ATTACHMENT TO WNP-2 CYCLE 5 RELOAD SUMMARY REPORT
TECHNICAL SPECIFICATION CHANGES

ATTACHMENT TO WNP-2 CYCLE 5 RELOAD SUMMARY REPORT
SUMMARY JUSTIFICATION FOR TECHNICAL SPECIFICATION CHANGES

Figure 3.2.1-6

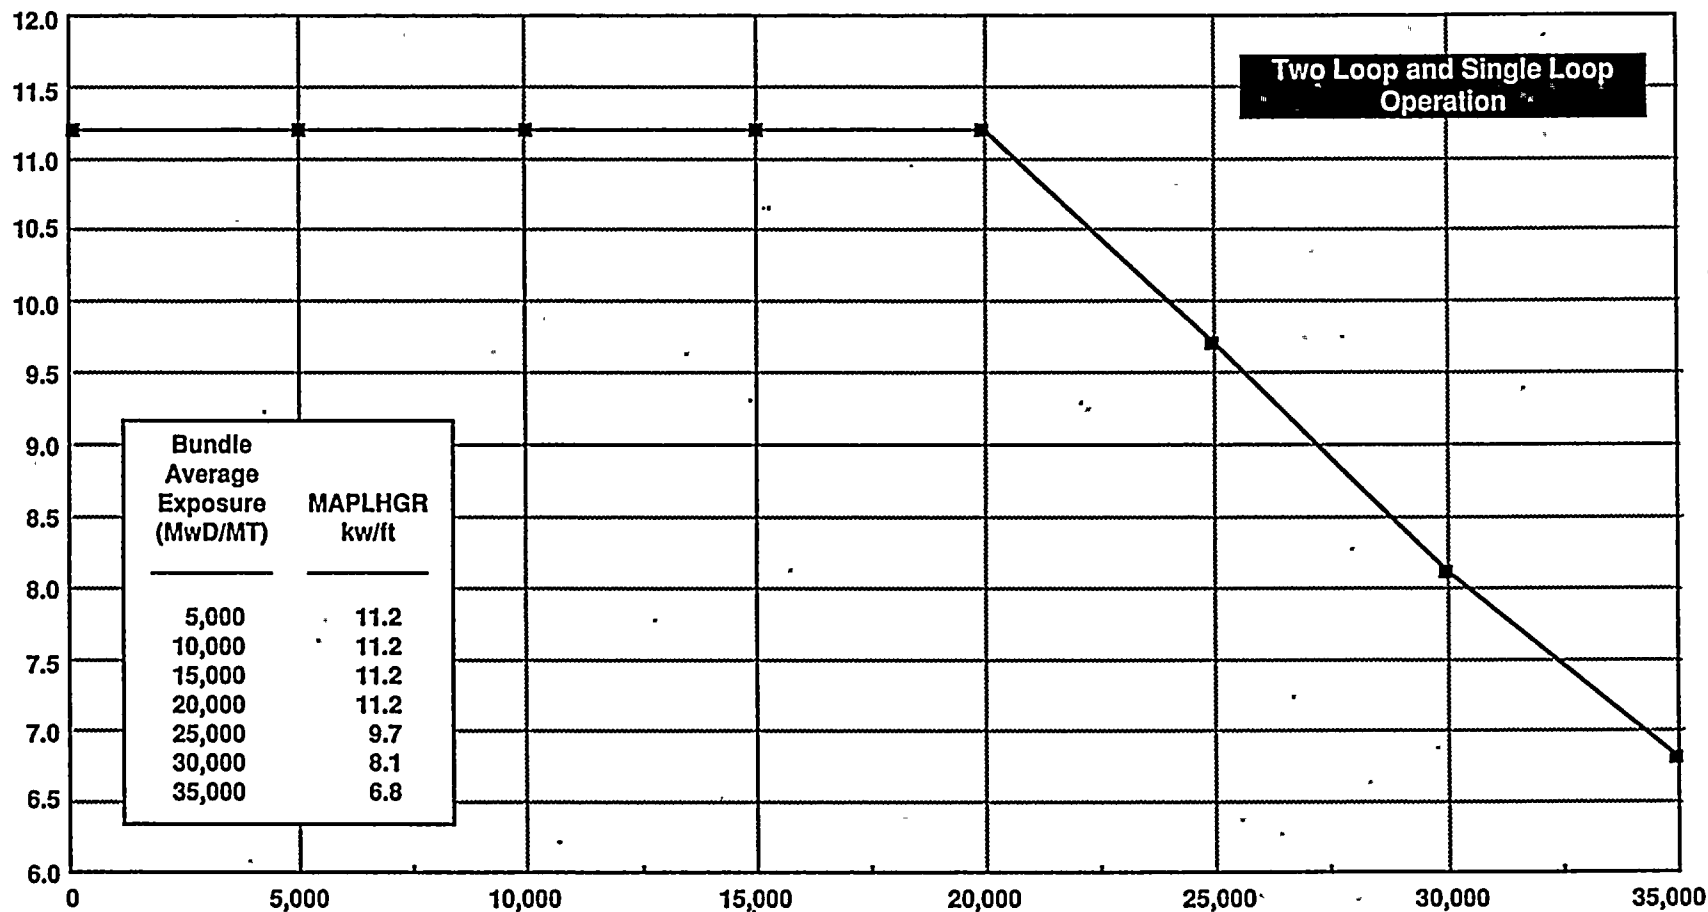
3.2.1 All AVERAGE PLANAR LINEAR HEAT GENERATION RATES (APLHGRs) for each type of fuel as a function of AVERAGE PLANAR EXPOSURE for GE fuel and average bundle exposure for ANF fuel shall not exceed the limits shown in Figures 3.2.1-1, 3.2.1-2, and 3.2.1-3 when in two loop operation, and Figures 3.2.1-4, 3.2.1-5, and 3.2.1-6 when in single loop operation. ^{and 3.2.1-6} 3.2.1-3

With an APLHGR exceeding the limits ^{3.2.1-3,} of Figure 3.2.1-1, 3.2.1-2, or 3.2.1-3 or 3.2.1-6 in two loop operation or Figure 3.2.1-4, 3.2.1-5, or 3.2.1-6 in single loop operation, initiate corrective action within 15 minutes and restore APLHGR to within the required limits within 2 hours or reduce THERMAL POWER to less than 25% of RATED THERMAL POWER within the next 4 hours.

4.2.1 All APLHGRs shall be verified to be equal to or less than the limits determined from Figures 3.2.1-1, 3.2.1-2, 3.2.1-3, 3.2.1-4, 3.2.1-5, and 3.2.1-6.

B2.1.2	Editorial change only to reflect change submitted and approved as Technical Specification Amendment No. 28.
3/4.1.3.4	This change corrects a previous oversight in the Tech. Specs. (see cover letter).
3/4.2.1	Addition of MAPLHGR curve for 9x9 fuel.
3/4.2.3	New MCPR values to reflect cycle specific transient analysis.
3/4.2.4	Addition of LHGR curves for 9x9-IX and 9x9-9X fuel.
B3/4.2.1	Editorial change to bases to reflect change to Tech. Spec. 3/4.2.1 discussed above.
5.3	Editorial change to Design Features to reflect the use of 9x9 lead test assembly fuel.

Reduced Flow MCPR Operating Limit
Figure 3.2.3-1

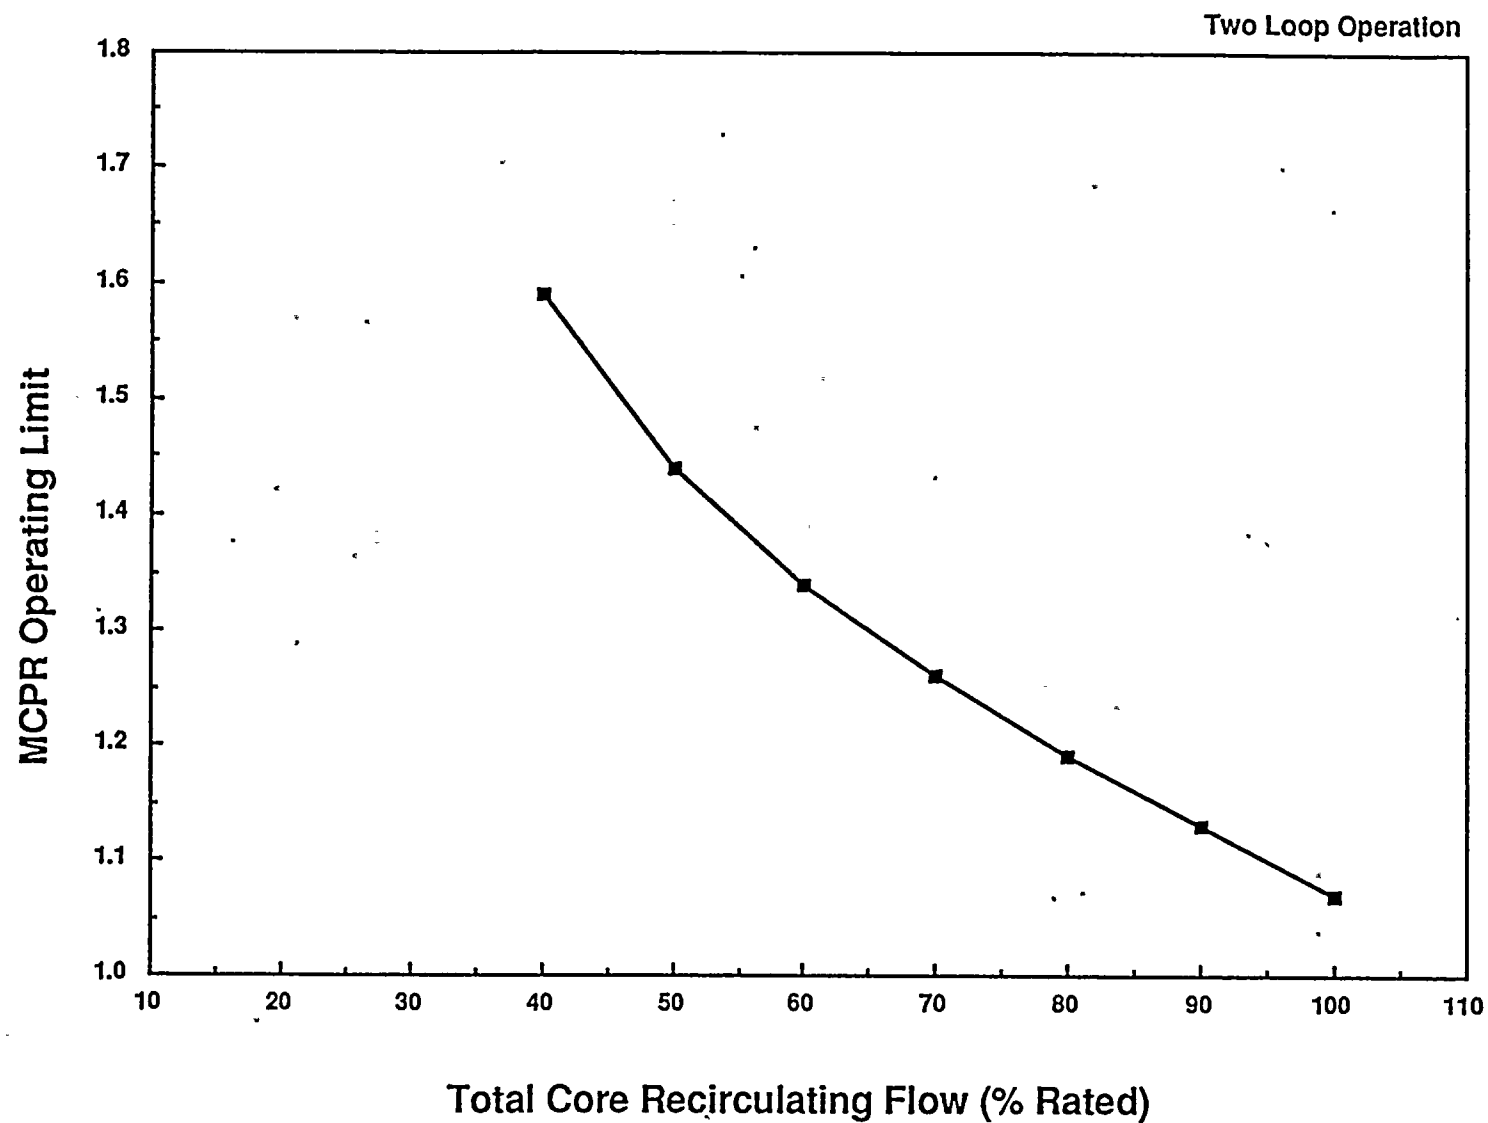
<u>Cycle Exposure</u>		<u>Equipment Status</u>	<u>GE Fuel</u>	<u>ANF Fuel</u>
1.	0 $\frac{\text{MWD}}{\text{MTU}}$ - 3750 $\frac{\text{MWD}}{\text{MTU}}$	*	1.40 1.24	1.28 1.24

2.	3750 $\frac{\text{MWD}}{\text{MTU}}$ - EOC $\frac{\text{MWD}}{\text{MTU}}$	Normal scram times**	1.40 1.35	1.31
3.	3750 $\frac{\text{MWD}}{\text{MTU}}$ - EOC $\frac{\text{MWD}}{\text{MTU}}$	Control rod insertion bounded by Tech. Spec. limits (3.1.3.4 - p 3/4 1-8)	1.50 1.42	1.38

4.	3750 $\frac{\text{MWD}}{\text{MTU}}$ - EOC $\frac{\text{MWD}}{\text{MTU}}$	RPT inoperable Normal scram times	1.50 1.42	1.37 1.38
5.	3750 $\frac{\text{MWD}}{\text{MTU}}$ - EOC $\frac{\text{MWD}}{\text{MTU}}$	RPT inoperable Control rod insertion bounded by Tech. Spec. limits (3.1.3.4 - p 3/4 1-8)	1.55 1.48	1.43 1.42
	0 $\frac{\text{MWD}}{\text{MTU}}$ - EOC $\frac{\text{MWD}}{\text{MTU}}$	Single loop operation RPT operable Normal scram times**	1.40	1.37

Figure 3.2.4-2

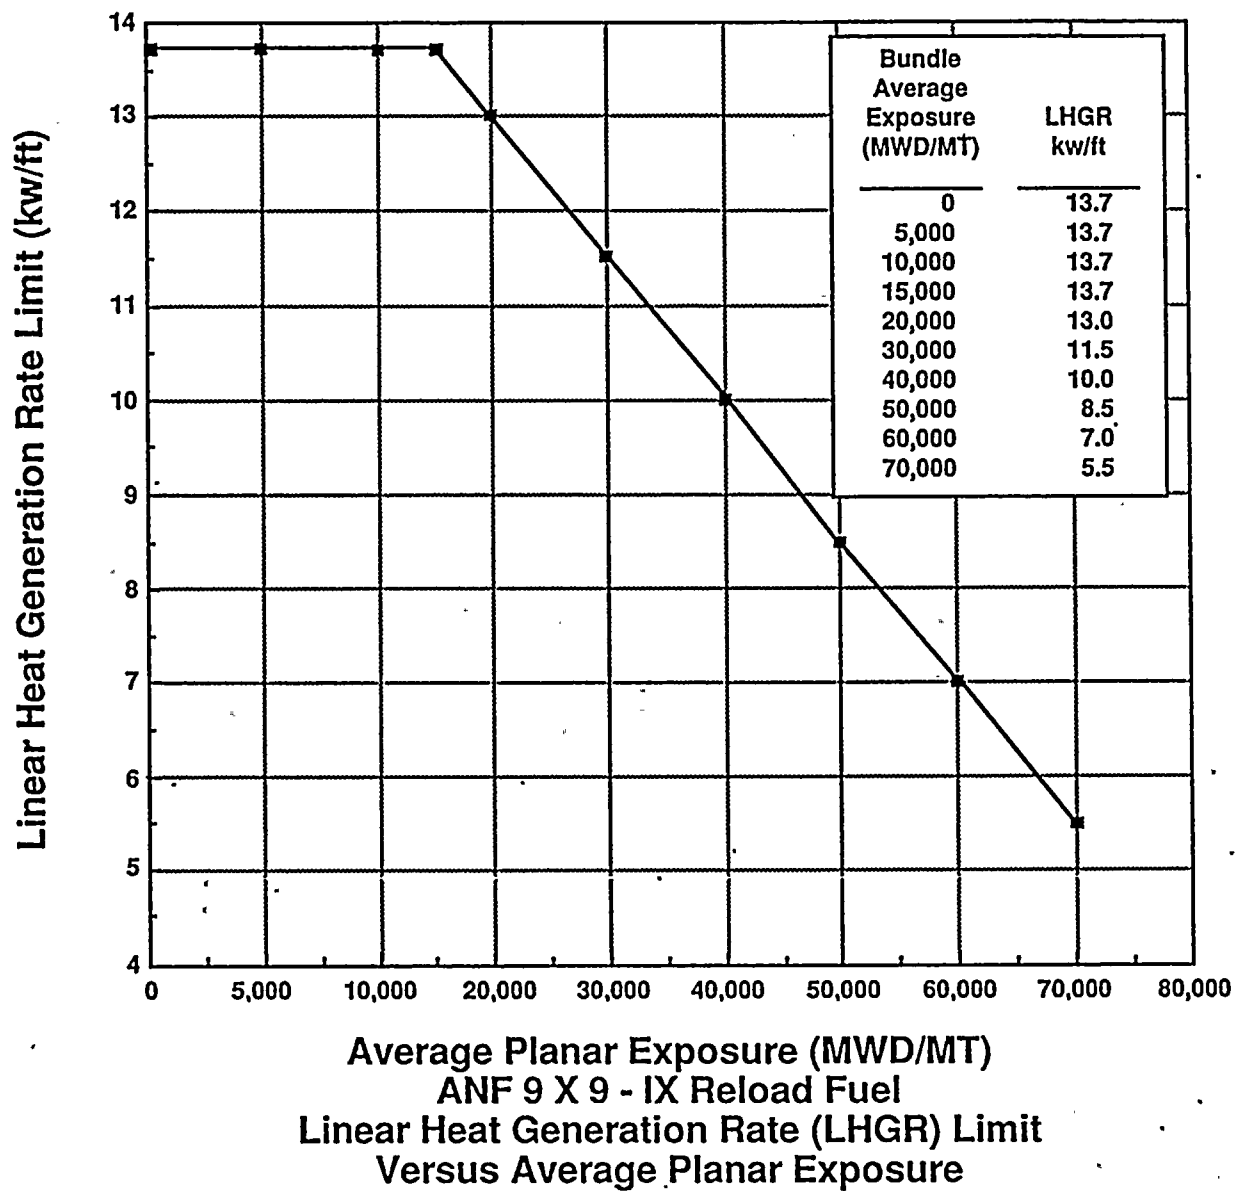
3.2.4 The LINEAR HEAT GENERATION RATE (LHGR) for GE fuel shall not exceed 13.4 kW/ft. The LHGR for ANF fuel shall not exceed the values shown in Figure 3.2.4-1, 3.2.4-2, and 3.2.4-3.
